Town of Milford Meeting Notice

Board or Commission: Conservation Commission

Date and Time of Meeting: Wednesday November 18, at 7.00 P. M

DRAWING NO.:
C-303

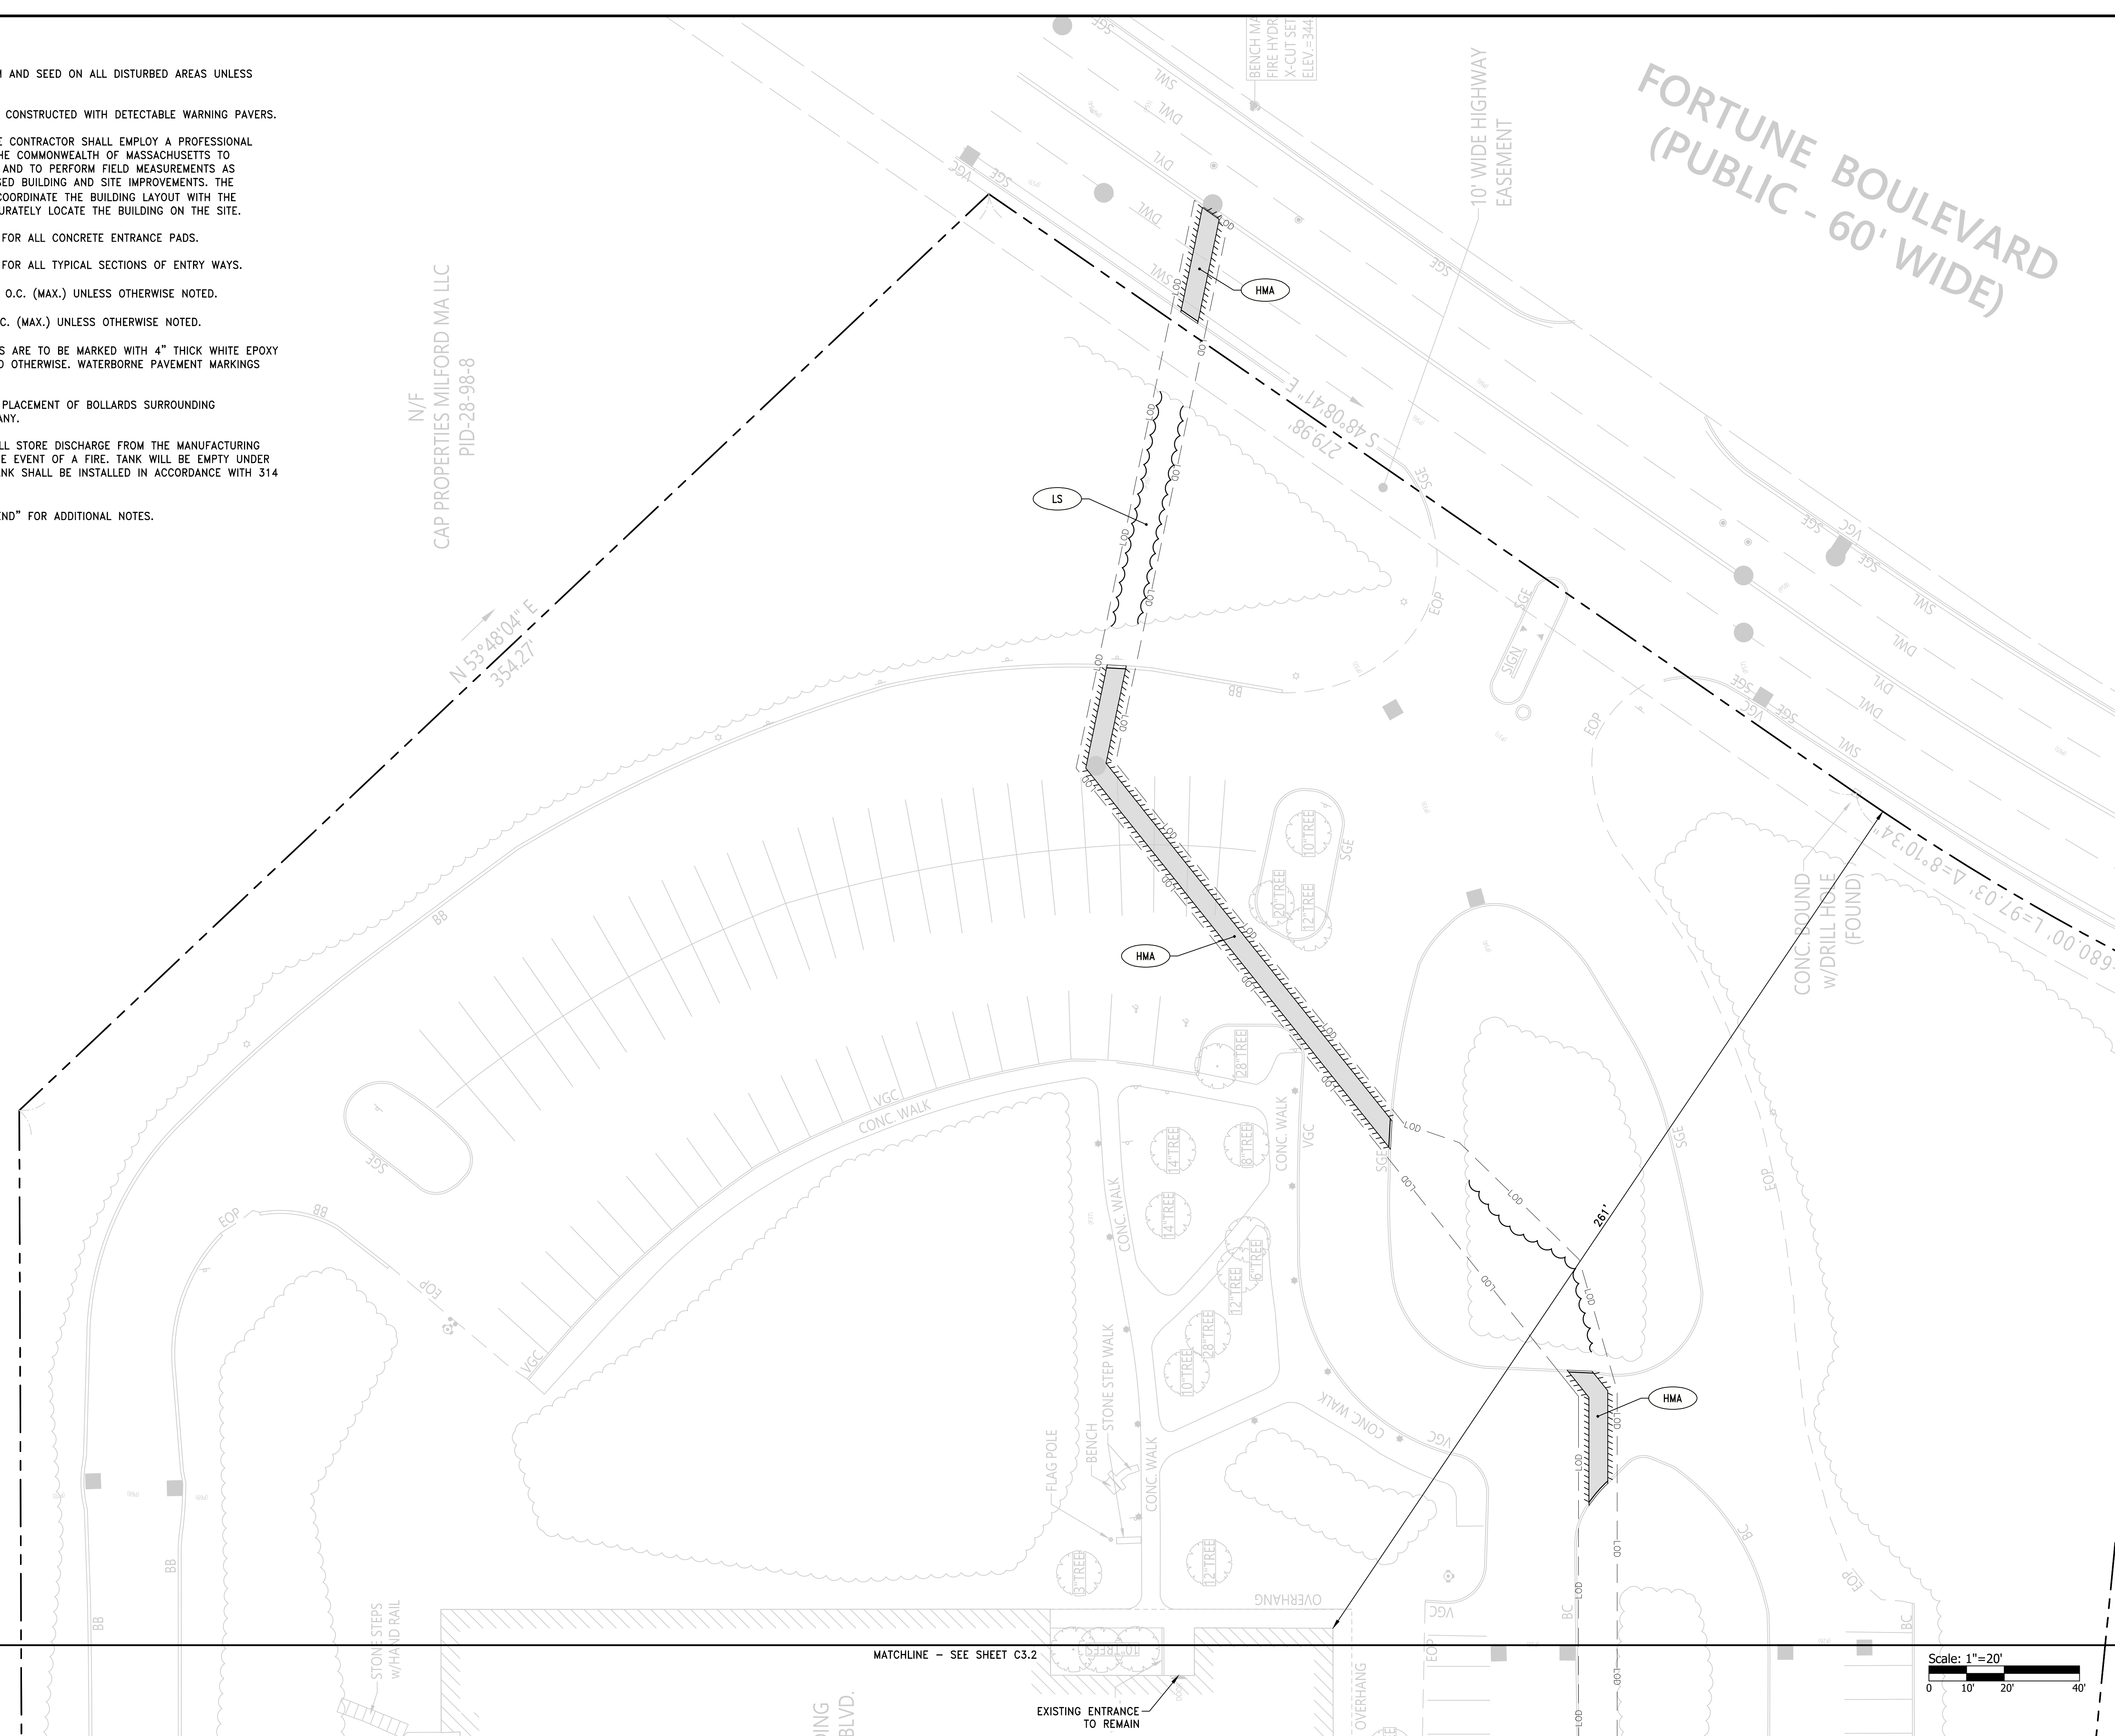
RESPONSE: *The erosion control detail on Sheet C-601 Civil Details 1 has been revised to include silt fence with the compost filter sock.*
